Steam Generator Inspection Program and Results

Answers to Questions

Indian Point Unit No.2
Docket No. 50-247
May, 1978

6 S.P.

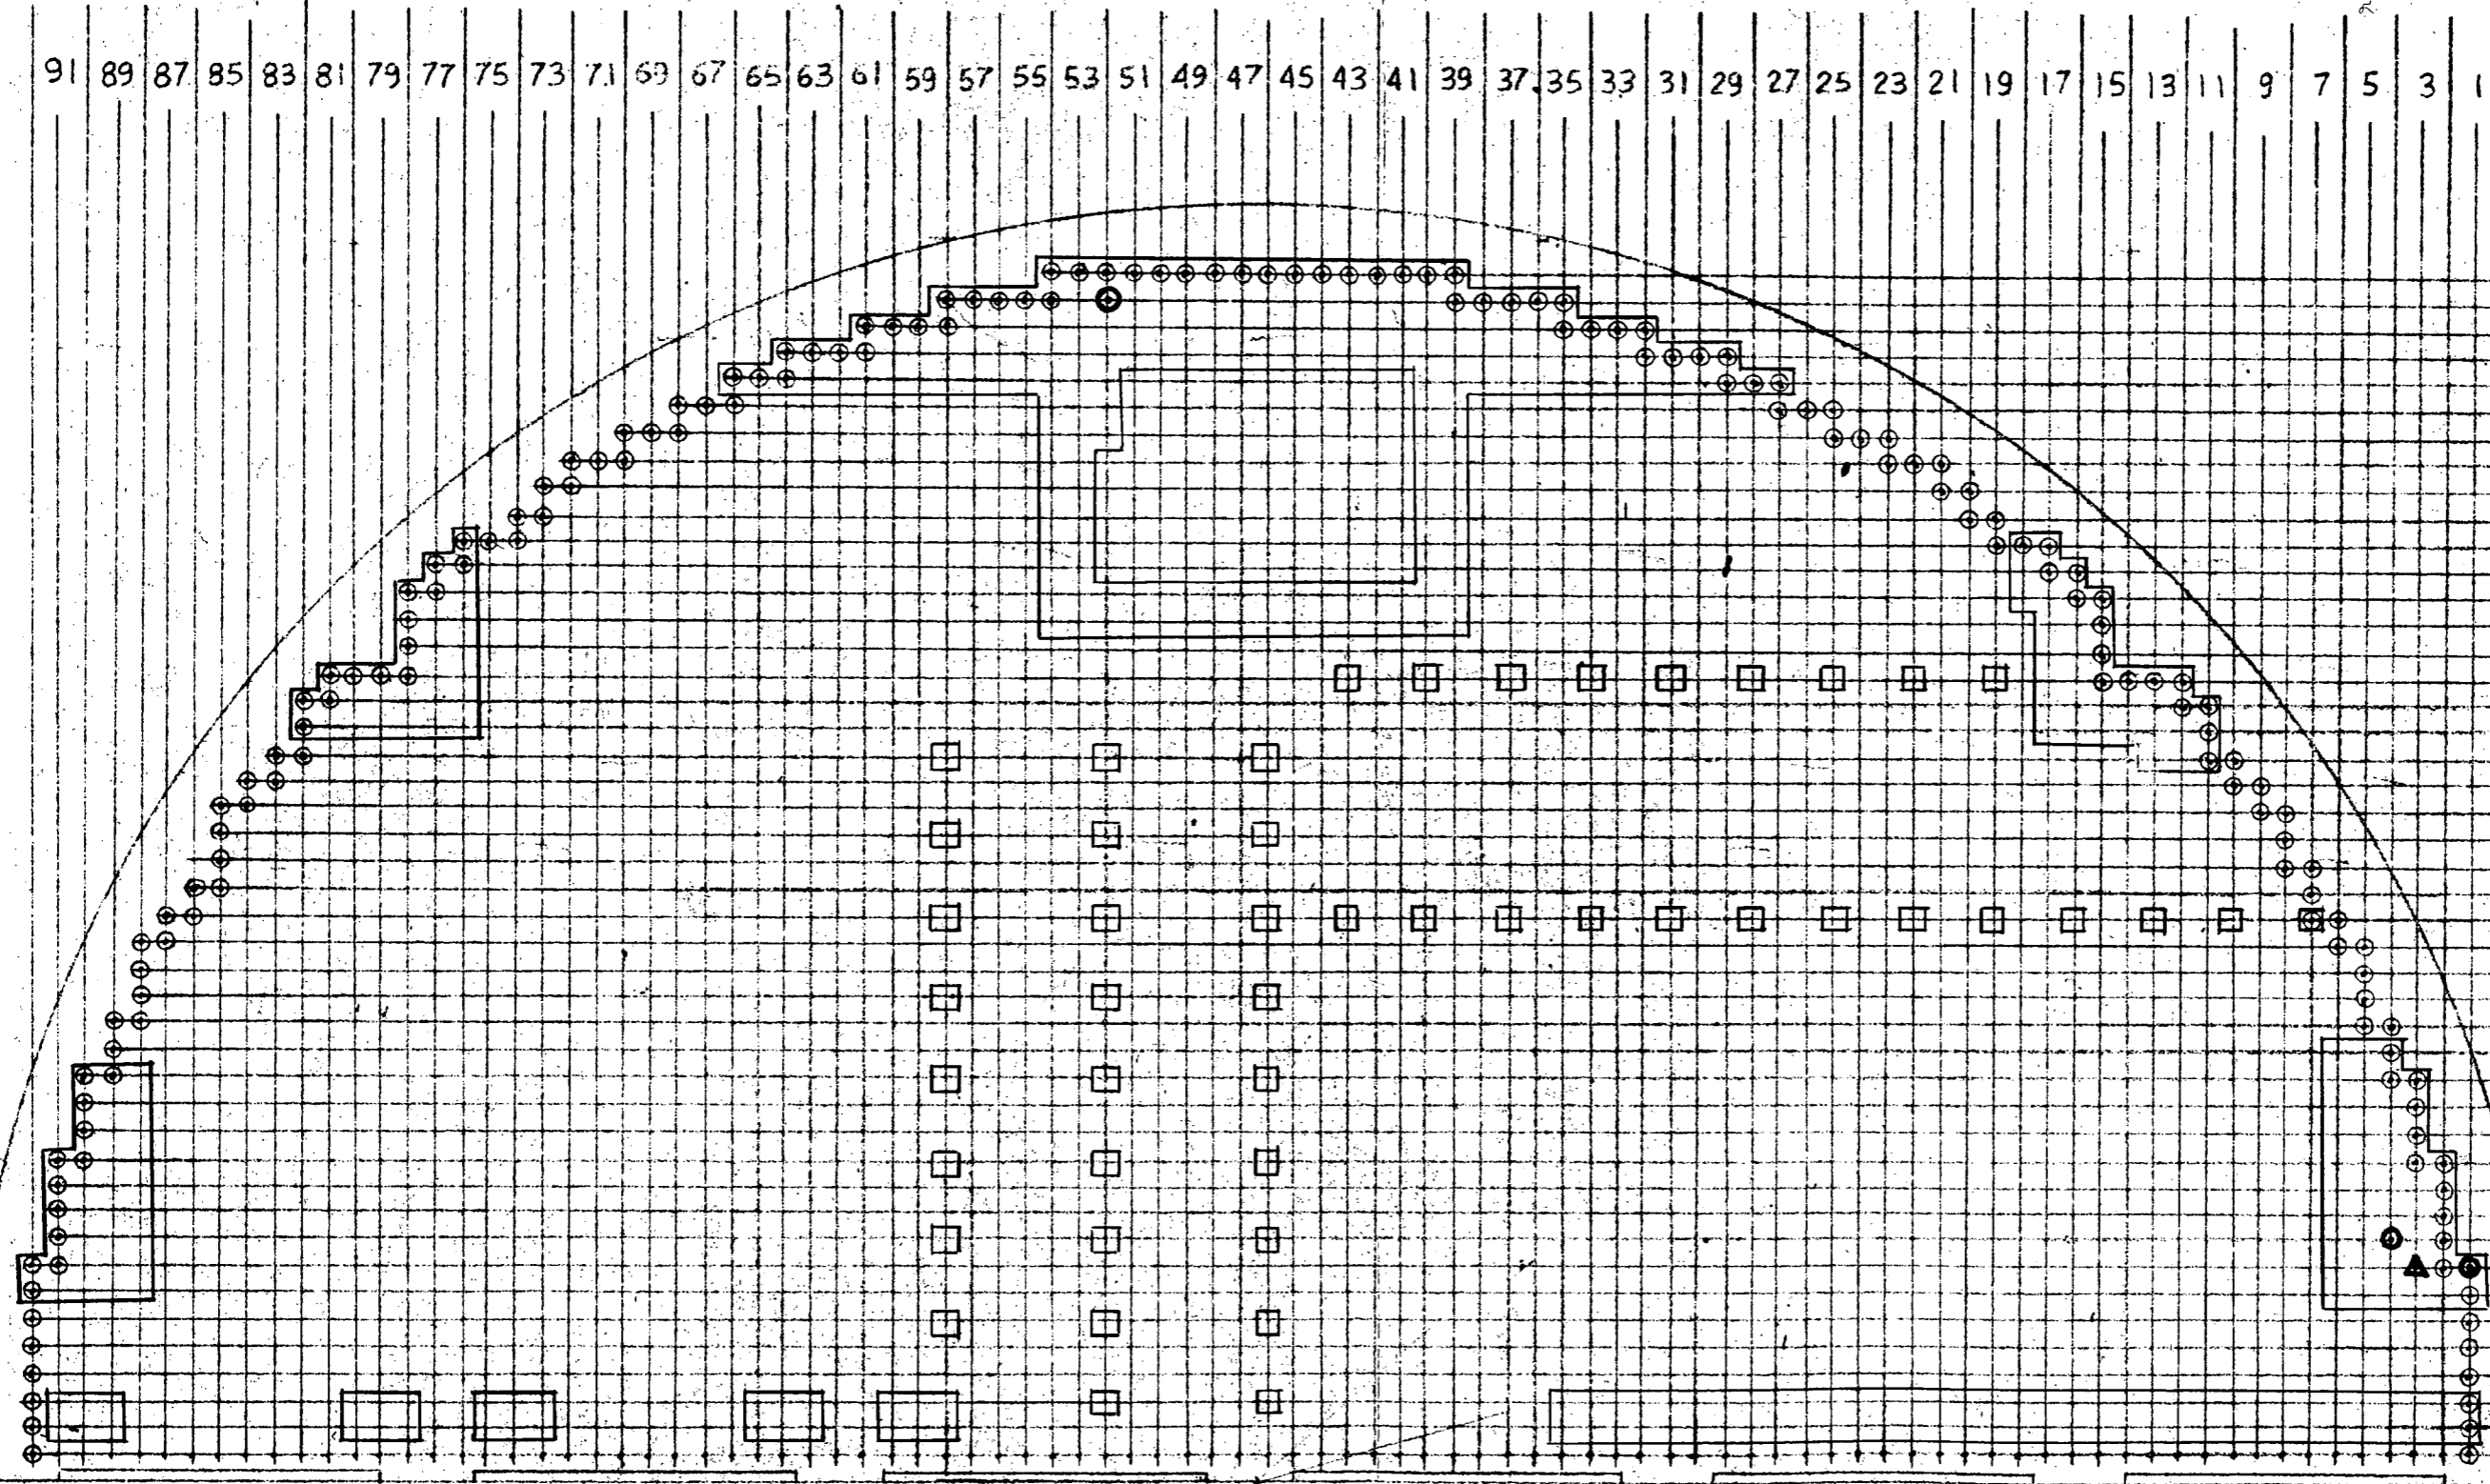
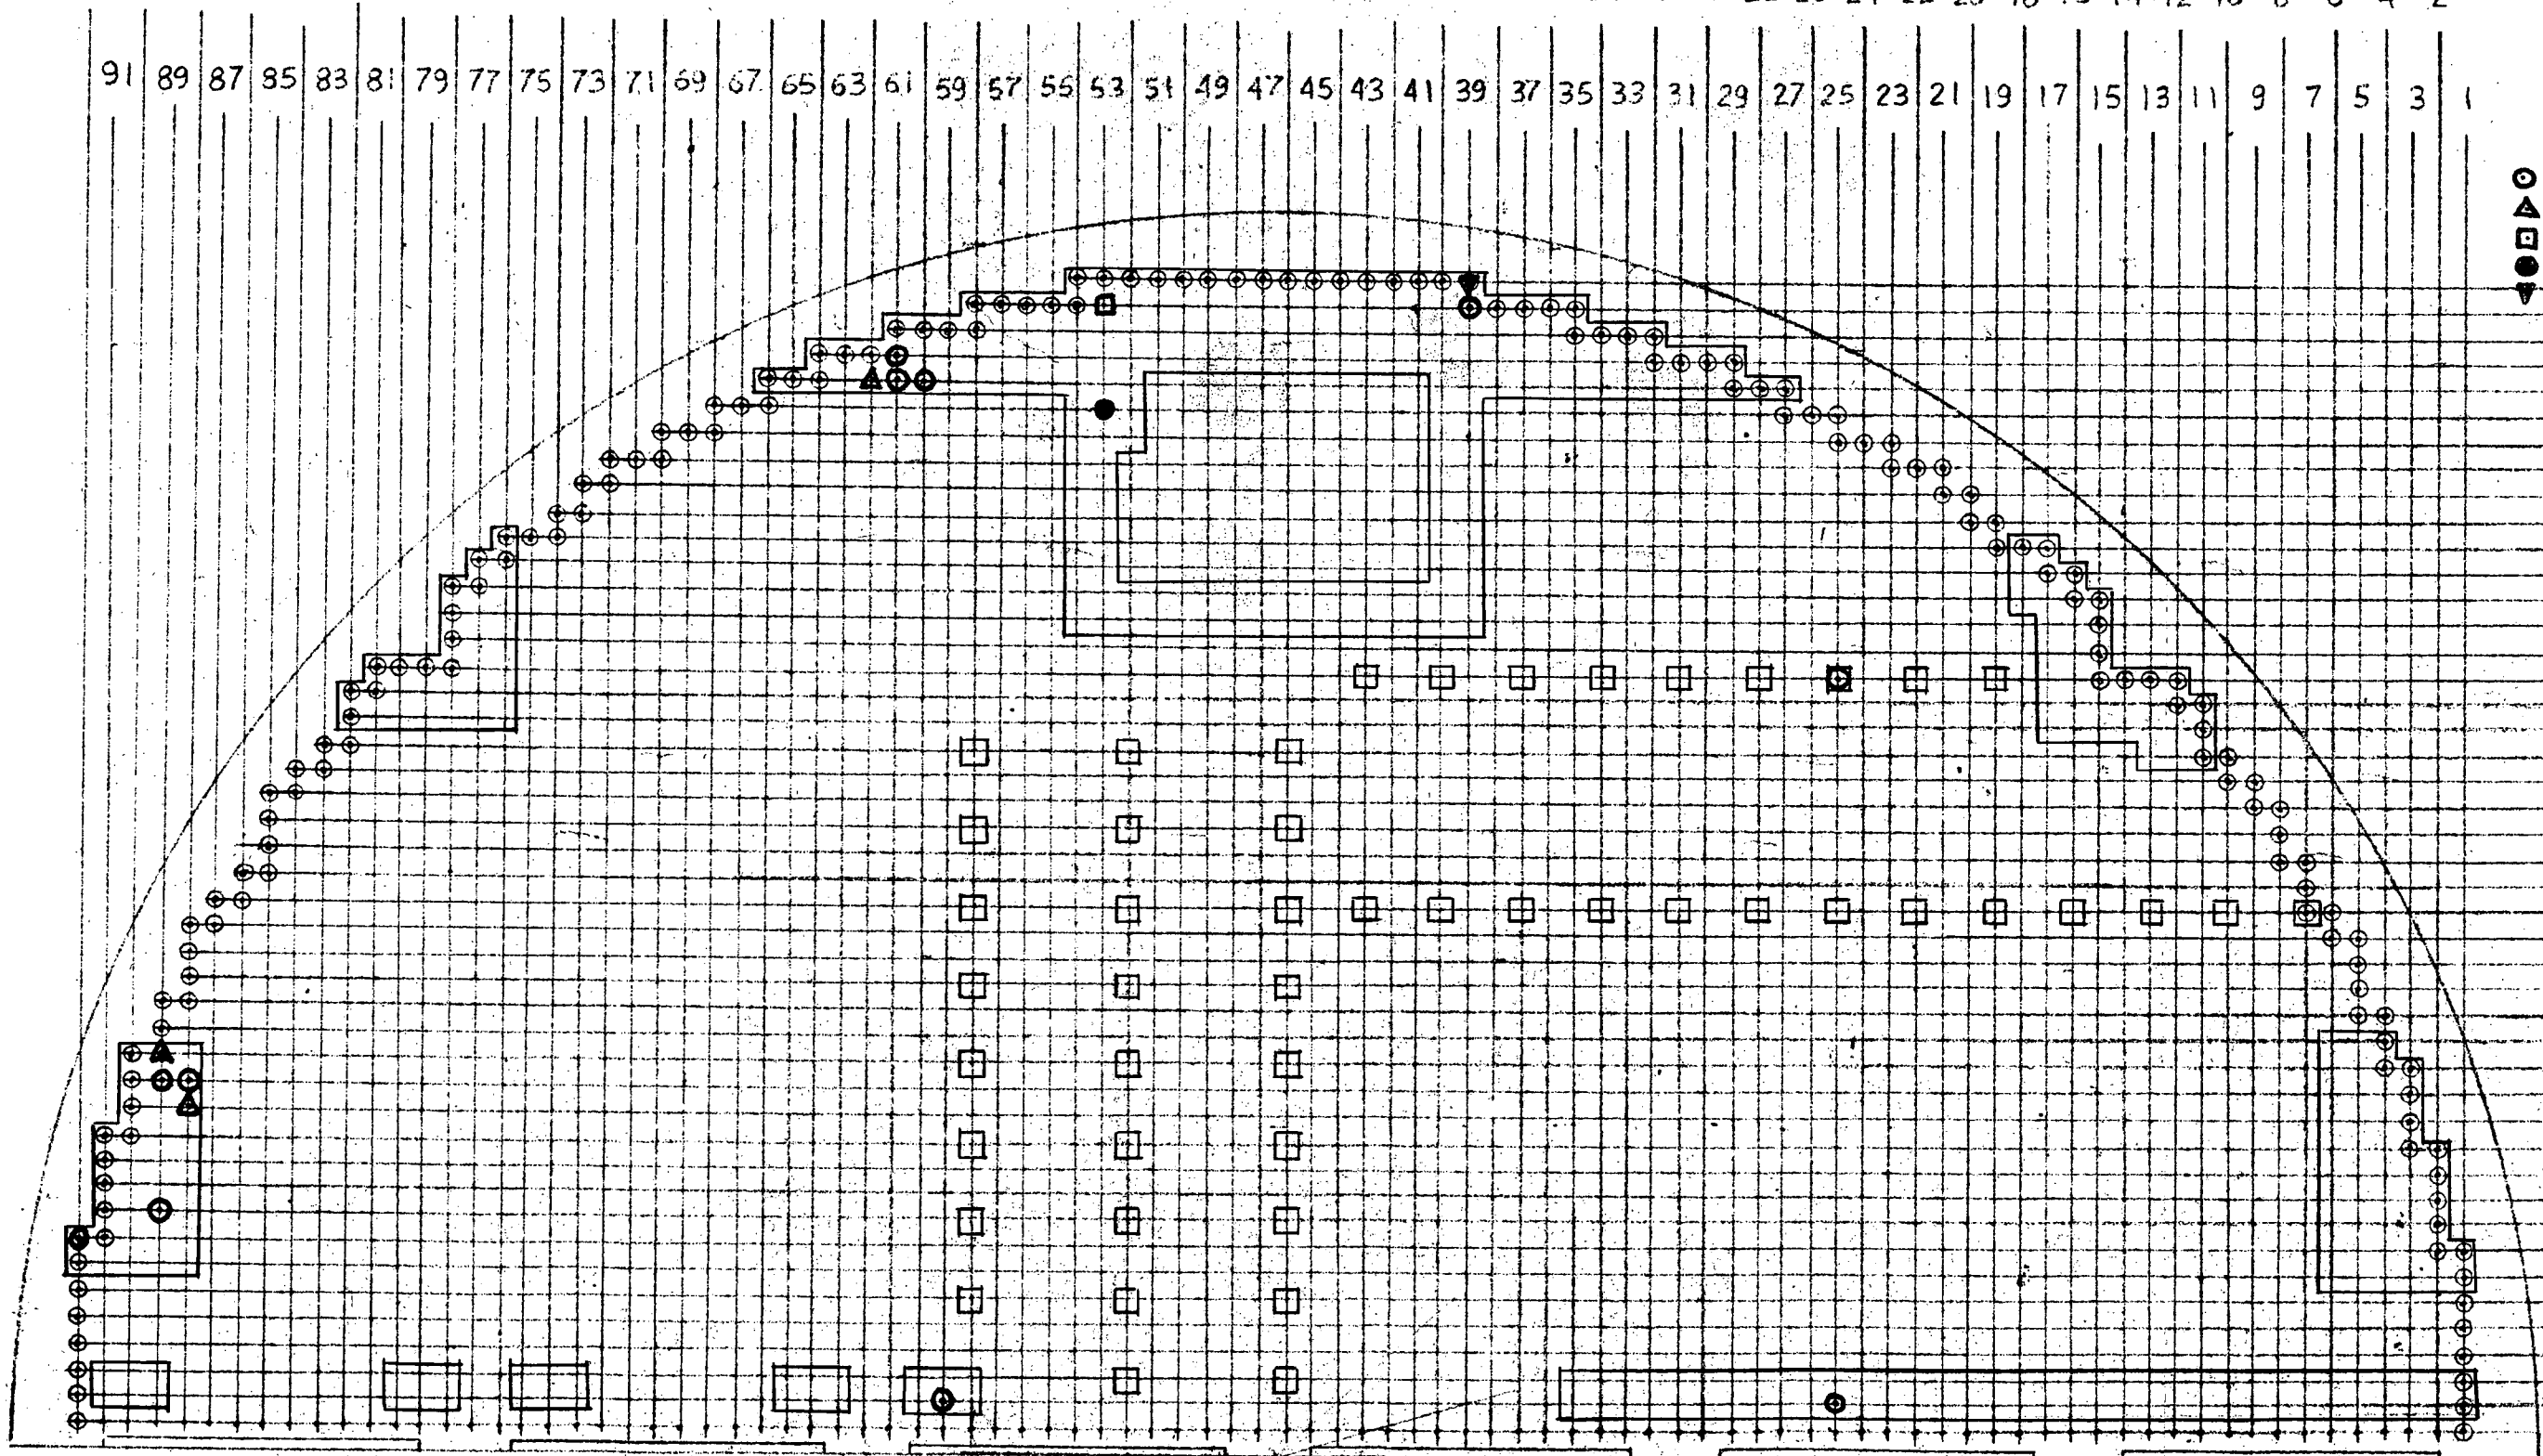
Please provide a map which shows the locations of steam generator tubes tested during the March, 1978 inspection which did not permit passage of the standard 700 mil eddy current probe.

Maps of the locations of all tubes which did not permit passage of the standard 700 mil probe are forwarded as Attachment B to this letter. These locations are coded to indicate the smallest probe size that would not pass through the tube. Those tubes for which the 700 mil probe was the smallest probe size not able to pass through the tubes are indicated by the heavily drawn circle at those tube locations.

The distribution of tubes which permitted passage of probes smaller than the 700 mil diameter probe is slightly different from that shown in our March 24, 1978 submittal because the tubes were reprobed and the data tabulated below is the most recent:

<u>Steam Generator 23</u>		<u>Steam Generator 24</u>	
<u>Smallest Probe Not Passed by Tube</u>	<u>Number of Tubes</u>	<u>Smallest Probe Not Passed by Tube</u>	<u>Number of Tubes</u>
700 mil	28	700 mil	55
675 mil	16	675 mil	7
640 mil	1	640 mil	2
610 mil	1*	610 mil	3*
540 mil	1*	540 mil	3*

*Plugged during 3/78 inspection program
